## TECHNICAL BULLETIN

<b>Product:</b>	Selector Rack Anti-rotation pin & washer				
<b>Reference No:</b>	CFT/004				
<b>To:</b>	CUPRA/AUDI				
<b>Author:</b>	JMB	<b>Date:</b>	01/09/2022	<b>Issue no.</b>	1

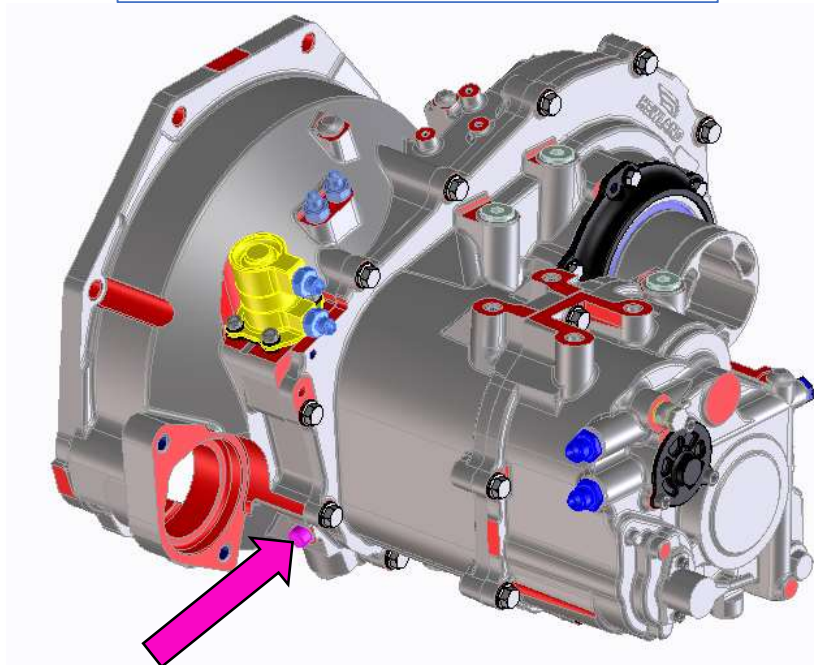
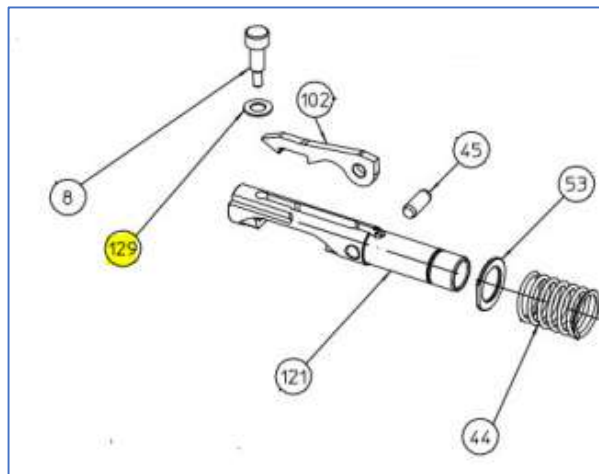
It should be noted that the washer (WSH-028) which sits under SCR-349 anti-rotation pin must be fitted. If this washer is omitted, the anti-rotation pin could cause the rack to stick. It should also be noted that using an incorrect specification washer could also have this effect. A washer no less than 1mm must be fitted (Hewland recommend only the correct WSH-028 is used)
